ADDENDUM NO. 4  
WATER SYSTEM IMPROVEMENTS  
CONTRACT 18-01  
GREENWAY BOULEVARD AND BACK VALLEY ROAD WATER LINE EXTENSIONS  
CONTRACT 18-02  
INDUSTRIAL PARK 500,000 GALLON ELEVATED WATER STORAGE TANK  
DAYTON, TENNESSEE  
WAUFORD PROJECT NO. 4630

Date of Addendum: June 3, 2019

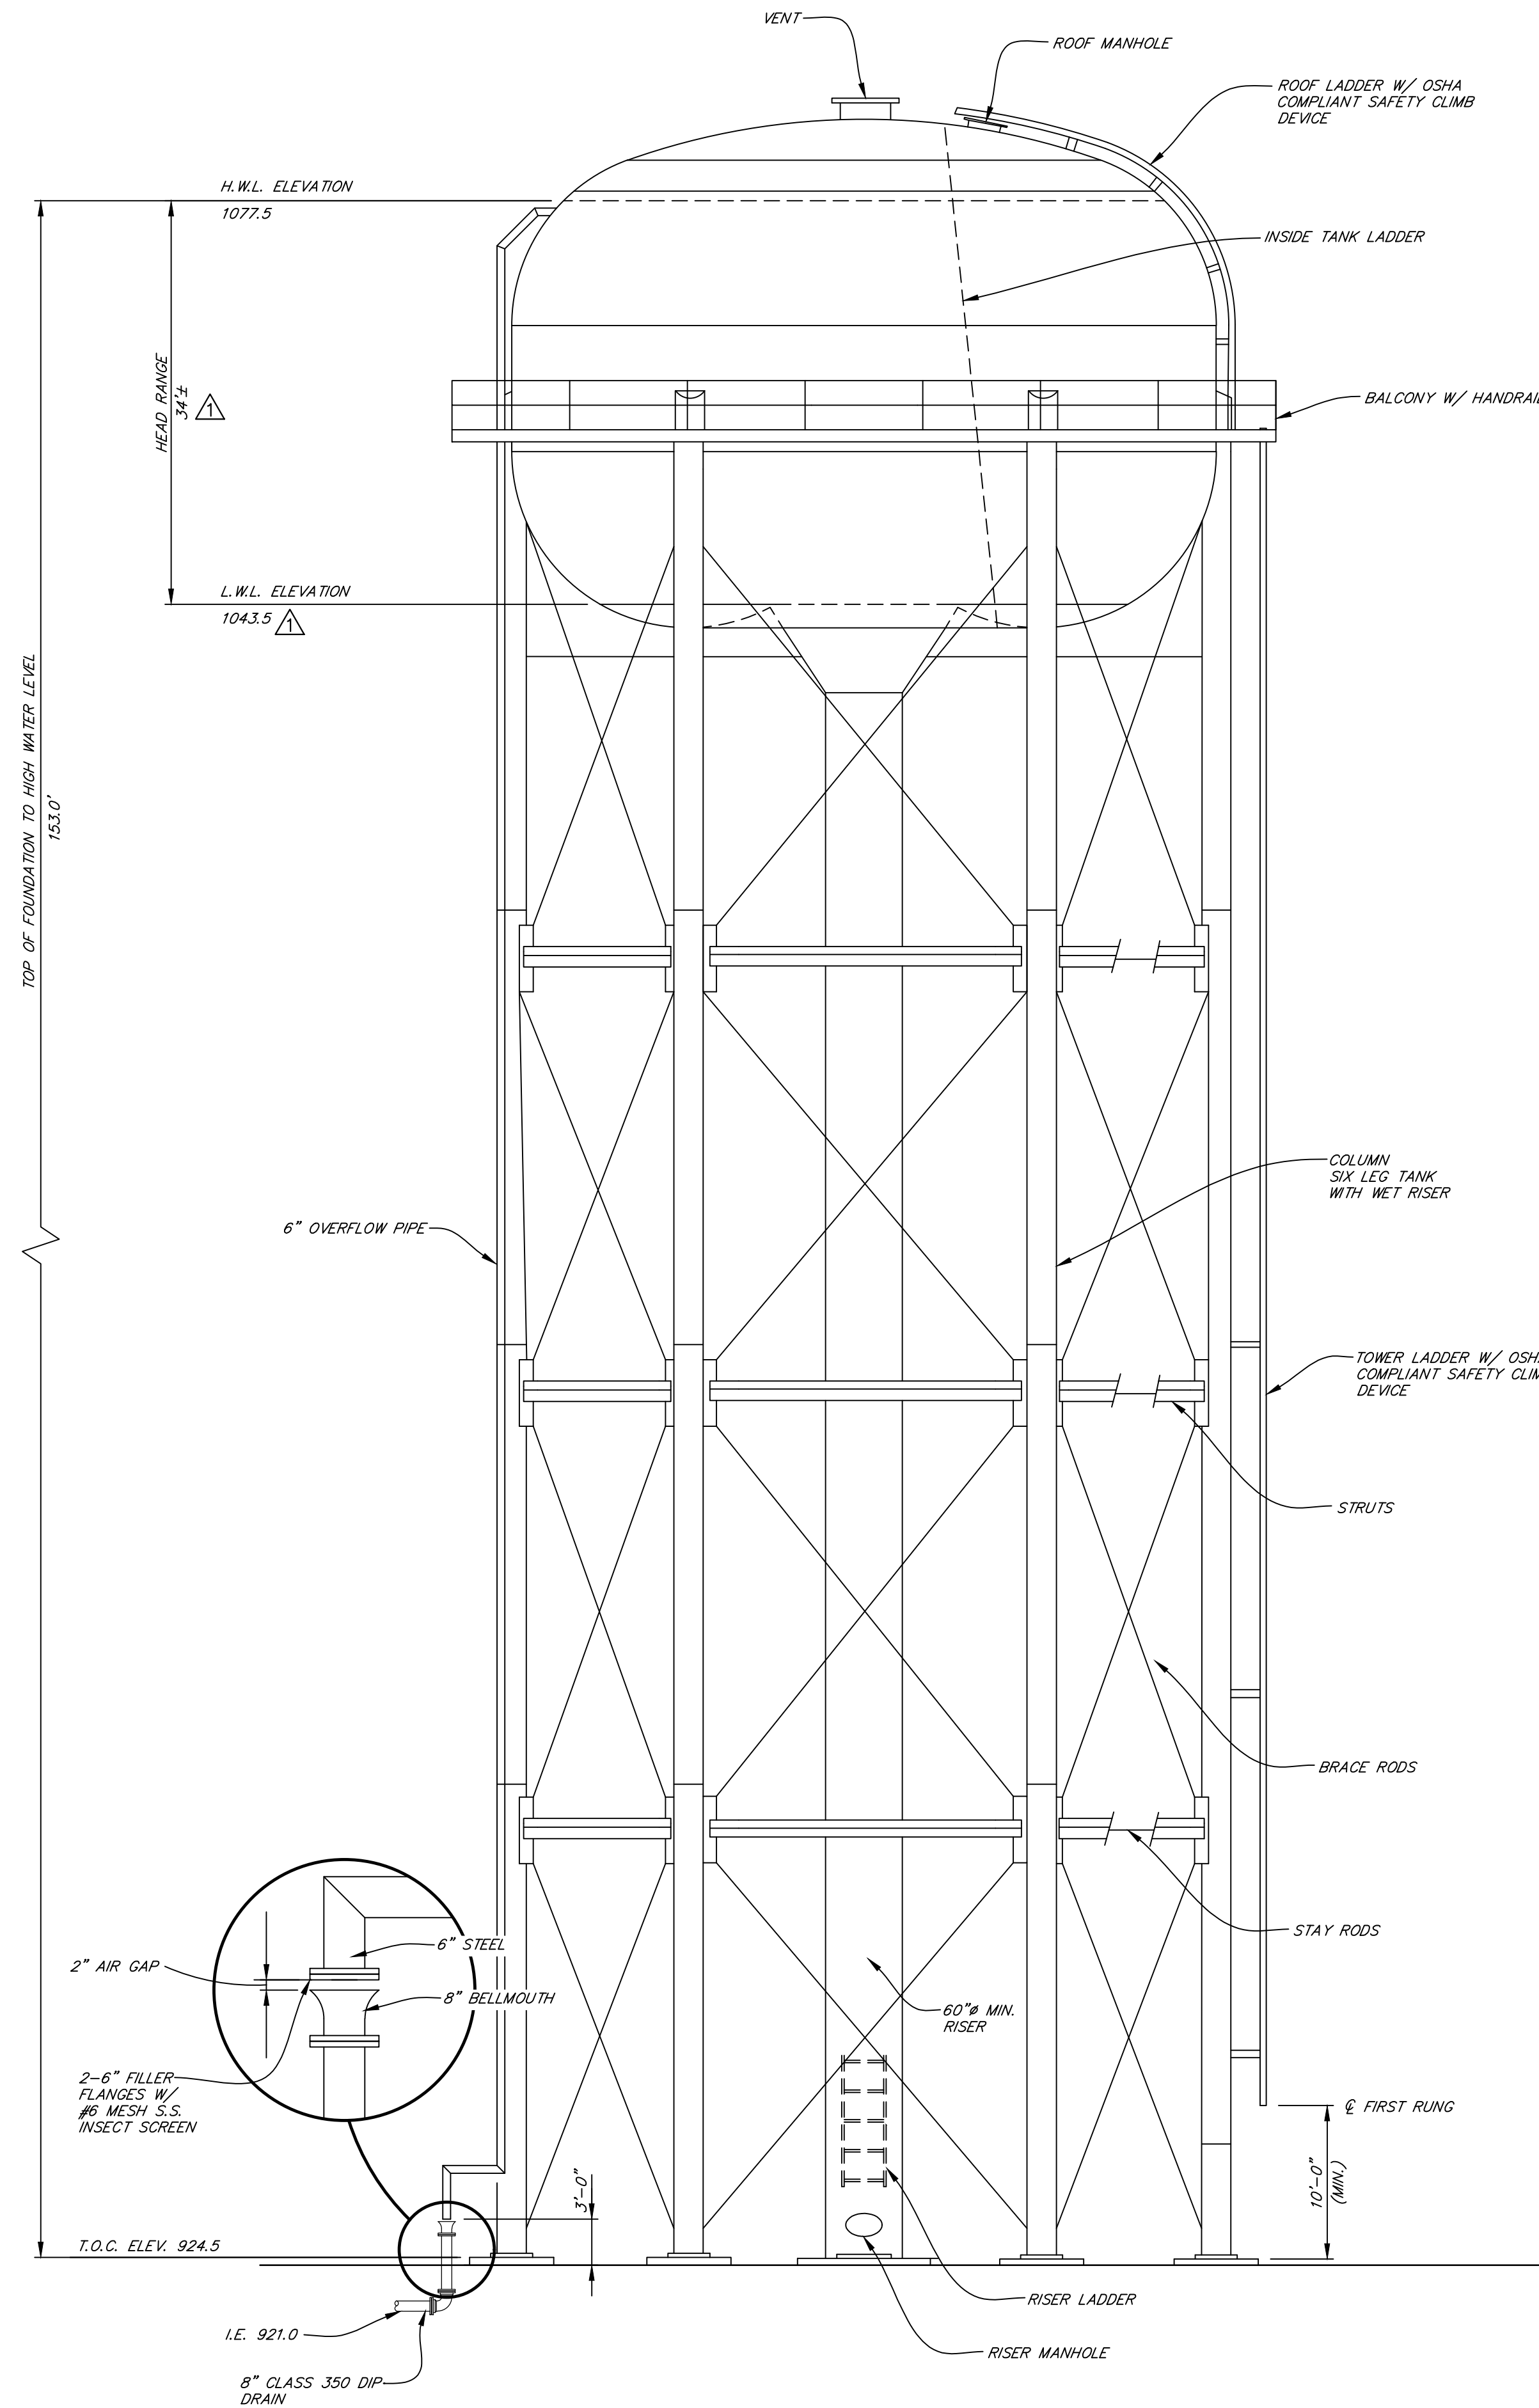
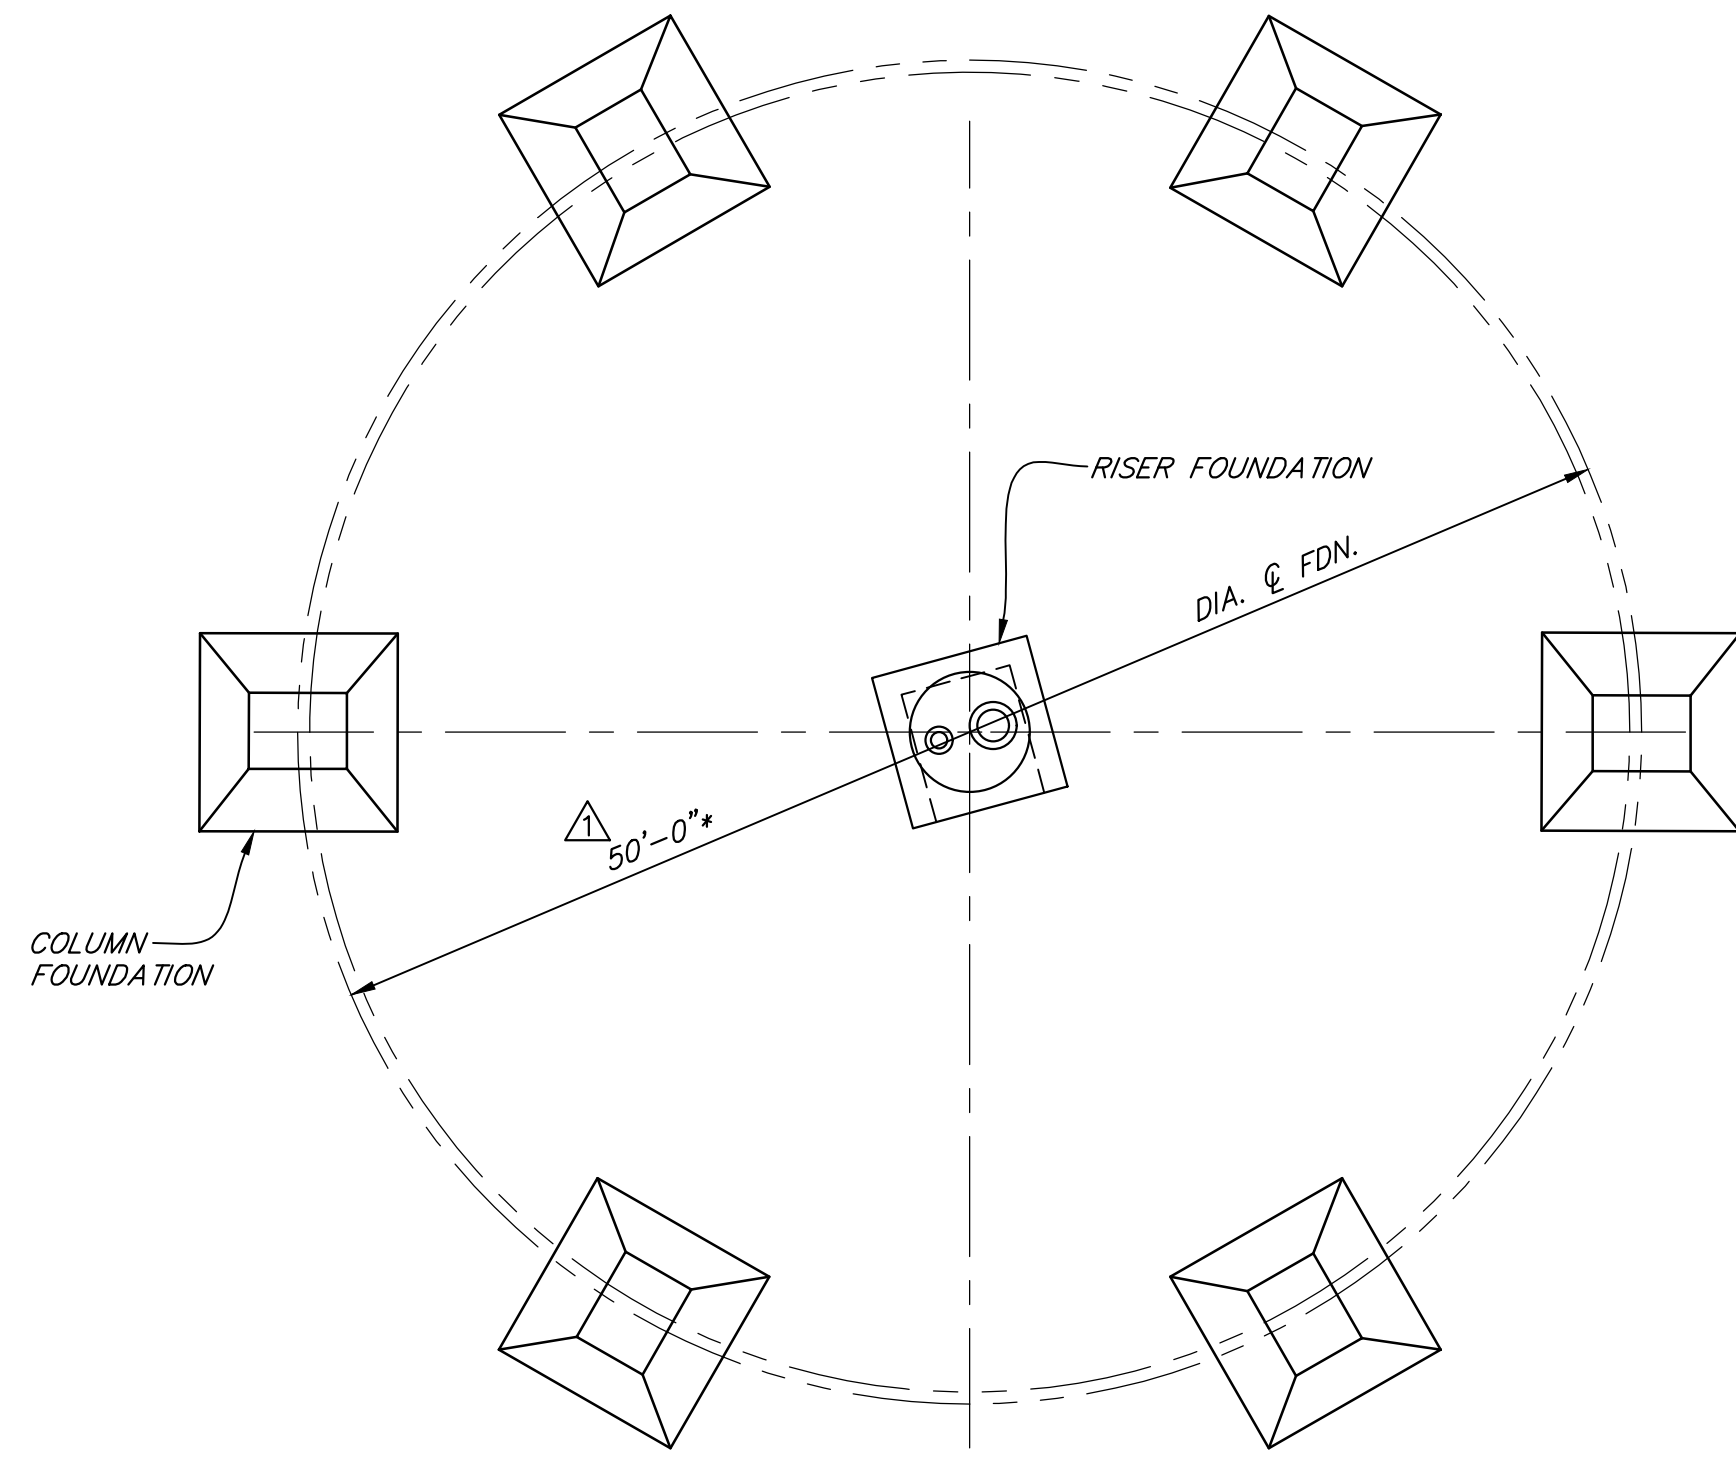
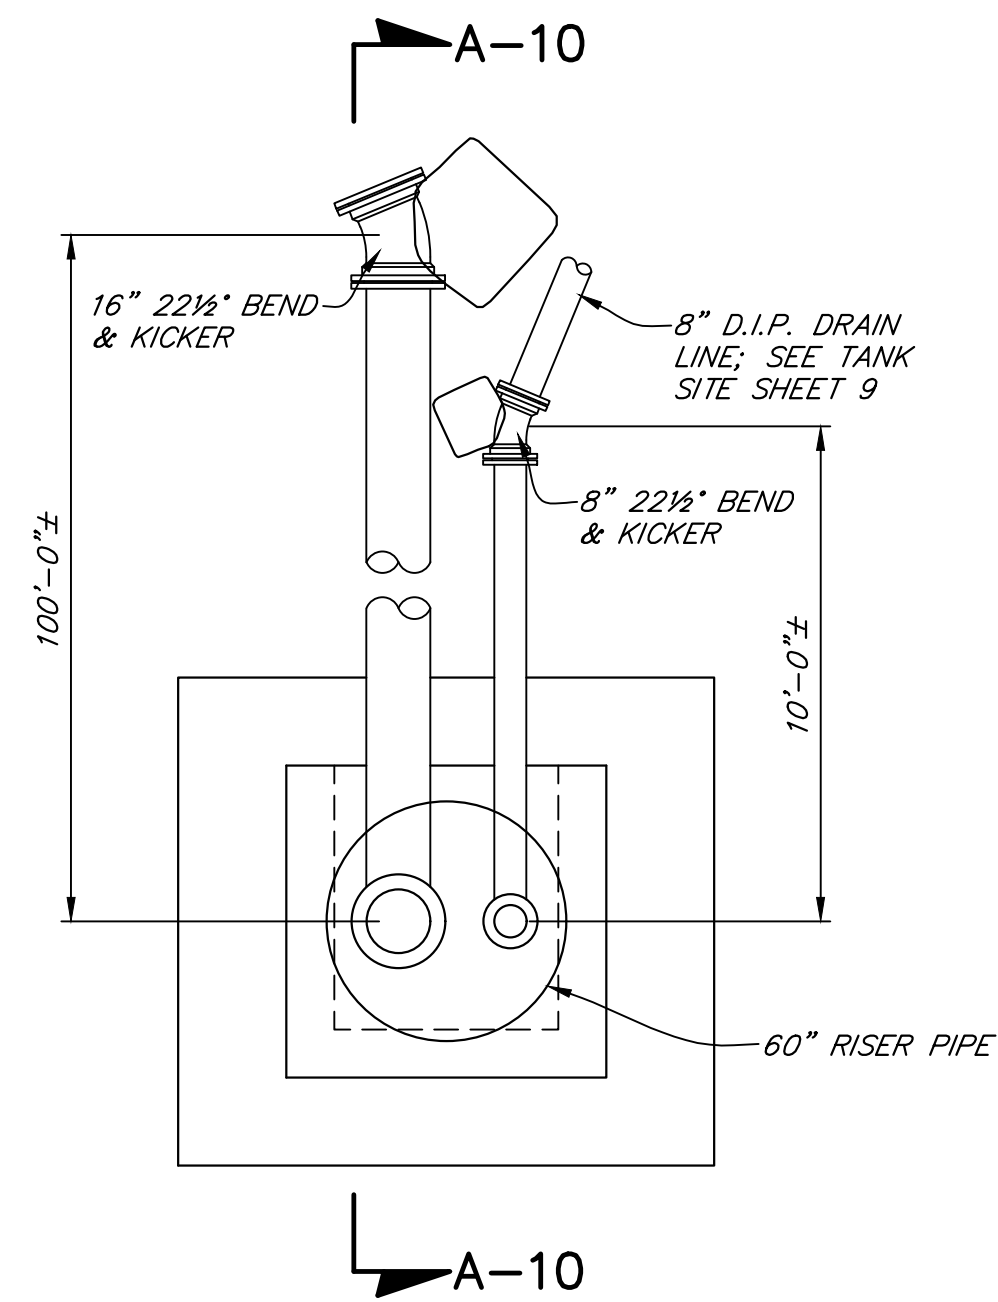
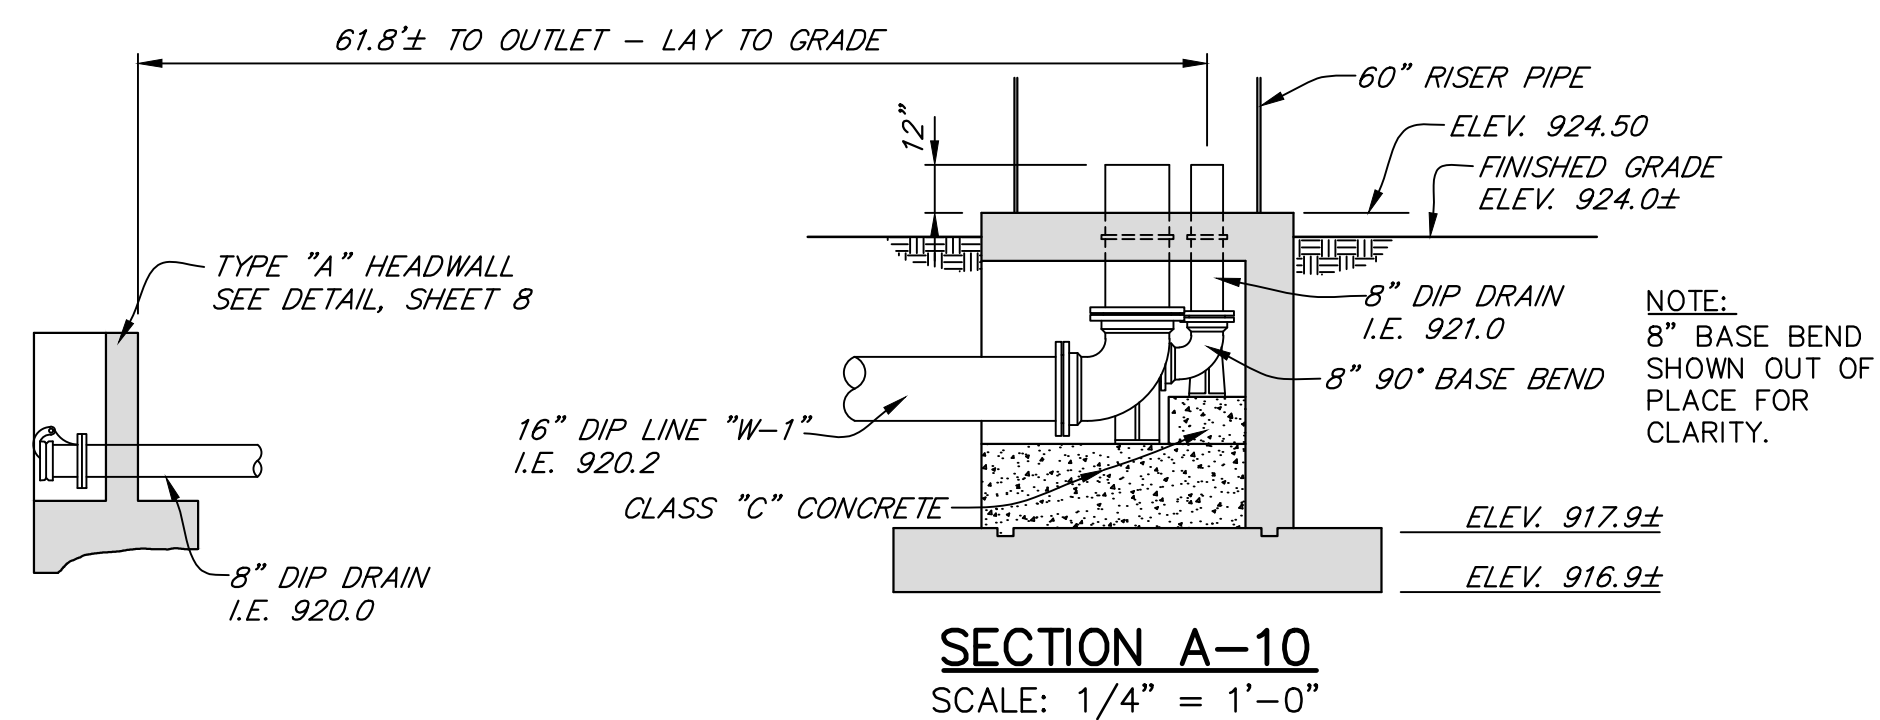
4. Plans, Sheet 10:

Revise as shown on attached Plans, Sheet 10.

1. SEE "GENERAL NOTES" AND "LEGEND", SHEET 1.
2. ALL MECHANICAL JOINT FITTINGS SHALL UTILIZE MEGALUG RESTRAINT GLANDS BY EBAA IRON OR APPROVED EQUAL IN ADDITION TO CONCRETE KICKERS.
3. THE TANK CONTRACTOR IS RESPONSIBLE FOR DESIGN OF THE FOUNDATION INCLUDING DEPTH AND REINFORCING STEEL.
